Report: Pinehaven Stream
ARI 100 Hydrological Assessment
Various Development Scenarios

Prepared For: Save Our Hills (Upper Hutt) Incorporated
Author: Robert Hall, R J Hall and Associates Ltd
Revision: FINAL (and signed)
Date: 05 November 2019

1.0 Executive Summary

*Figure 5 - Beca "Pinehaven Stream Flood Mapping Audit" (13 July 2015)
Sub-catchment B Hydrographs - Existing Hydrographs (OS1, with Climate Change (CC) and Future (DS1, with CC))*

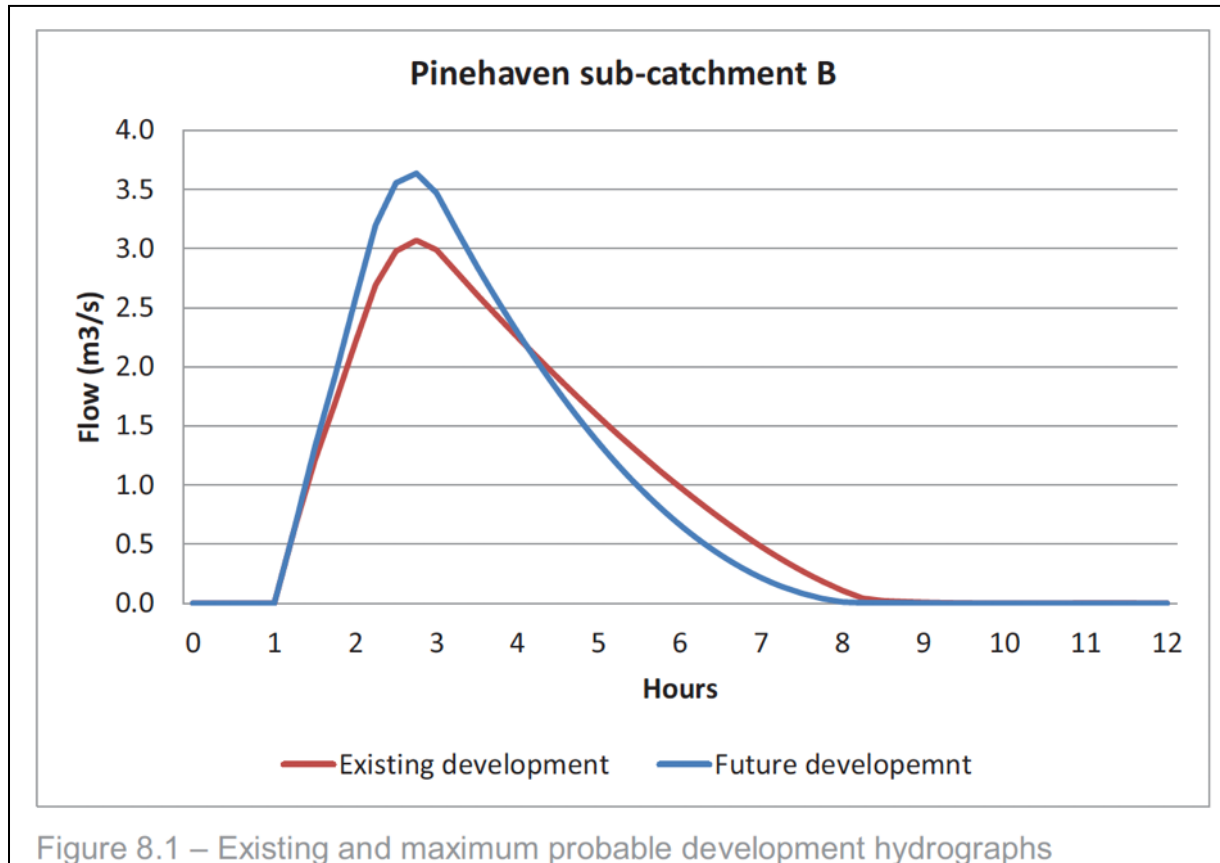
An audit by Michael Law (Beca, 2015) provided pre- and post-development [DS1] hydrographs for sub-catchment B (Figure 5) and estimated the increase in post-development [DS1] peak flow to be 18%, with the runoff volume increasing 5.6%.

*"Figure 8.1 [see RJH Figure 5] shows the change in flood hydrographs for existing development ... and future development ... for sub-catchment B, which is in the southwest of the catchment and drains to the top of Pinehaven Road. Future development increases the peak flow by 18% (from 3.07 m³ /s to 3.64 m³ /s), ... However, **the flood volume does not increase. This is unexpected, as increasing the impervious area of sub-catchment by 40% to reflect the development would be expected to reduce rainfall losses and increase runoff volume.** Similar results were found for sub-catchment E, which drains to Wyndham Road. Assuming a 100-year ARI plus climate change rainfall depth of 87.1 mm for the 3-hour storm, an Initial Loss of 5mm, Ongoing Loss of 2mm/hr, and 40% impermeable area for the affected post-development sub-catchments, then **the effective rainfall depths would be 76.7mm (88%) for existing land use, 80.8mm (93%) for post-development land use ... only 5.6% increase in effective rainfall post-development. ...***

The difference between existing and post-development flood volumes would be expected to be a similar ratio. ... The issue of no increase in post-development flood volume was raised with MWH, but they have not been able to provide an explanation as to why there is not an increase in flood volume. While this does not affect the validity of flood extents defined for current development, **it does invalidate the post-development flood extents and reduces community confidence in the flood mapping process.**” Beca “Pinehaven Stream Flood Mapping Audit” 2015, pp26,27 – (emphasis by RJ Hall & Assoc. Ltd)

Figure 11- Pre and Post Development OS1 and DS1 Hydrographs

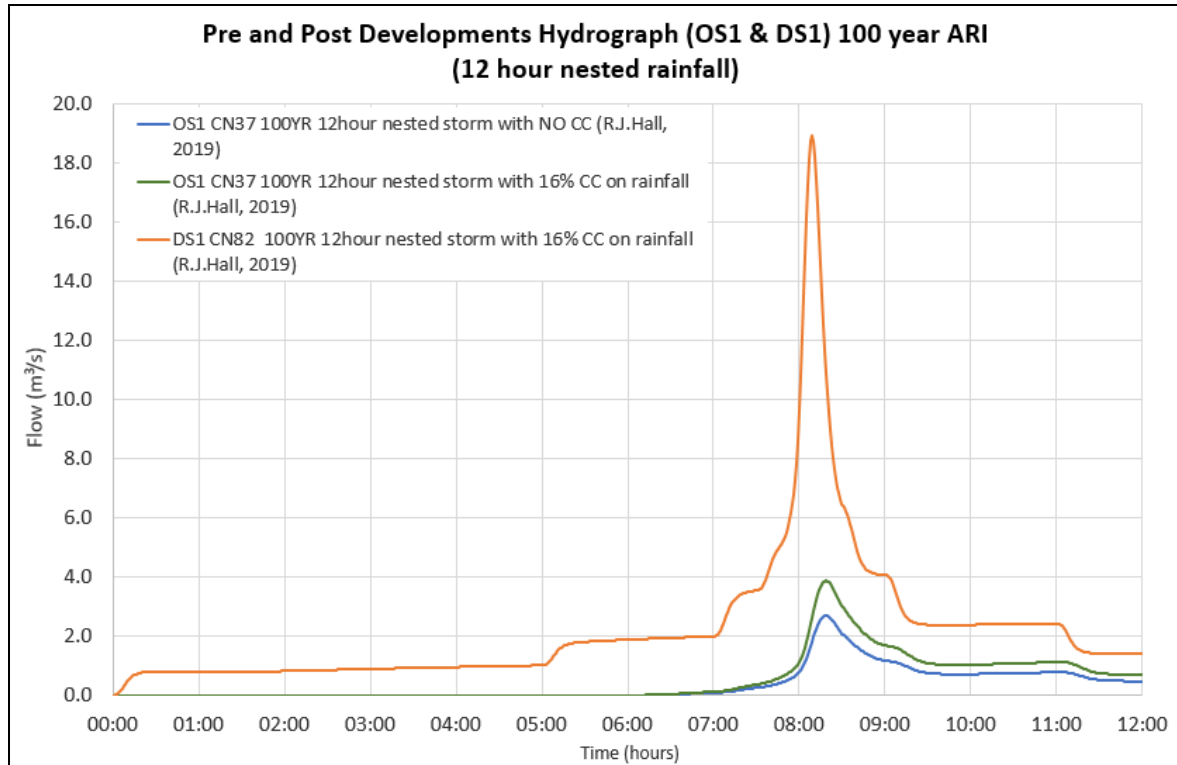
This present study finds (when the pre-development case is assessed without climate change) the increase in unmitigated runoff for the DS2 scenario is 71,214 m³ (i.e. 13,377 m³ increasing to 84,591 m³, a gain of 632%), and for the DS2A scenario it is 125,525 m³ (i.e. 19,671 m³ increasing to 145,196 m³, a gain of 738% - see Table 2 above). The 0.5% increase in flood volume supposed by Beca and Jacobs will, in reality, be more than 600% increase in flood volume.

Figure 14 - Pre and Post Development OS1 and DS1 Hydrograph Comparison (Jacobs, 2016 and R.J.Hall and Associates Ltd, 2019)

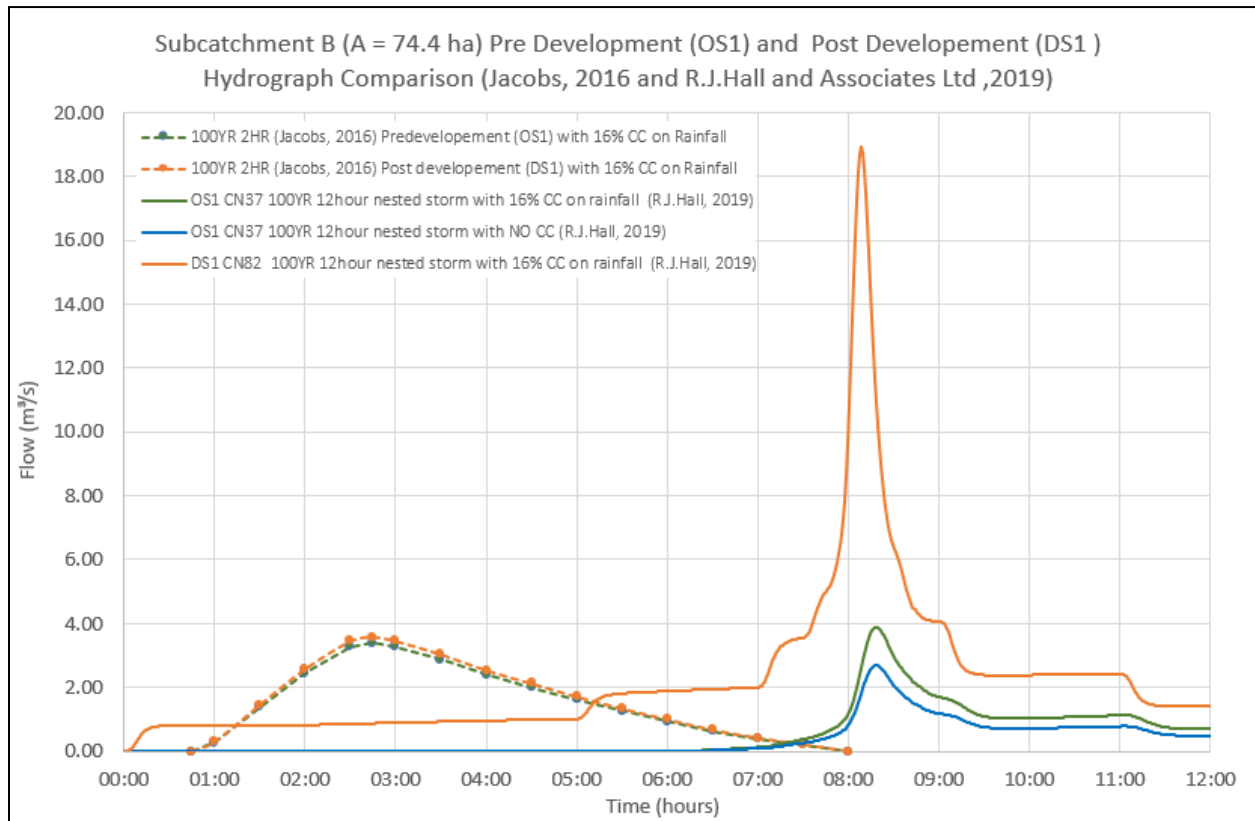
that the unmitigated effects that will be generated are likely to be minor where in reality that will not be the case (refer section 4.0 and Figure 14);

5.0 OS1 and DS1 Hydrograph Comparisons (Jacobs (2016) and R.J.Hall and Associates Ltd (2019))
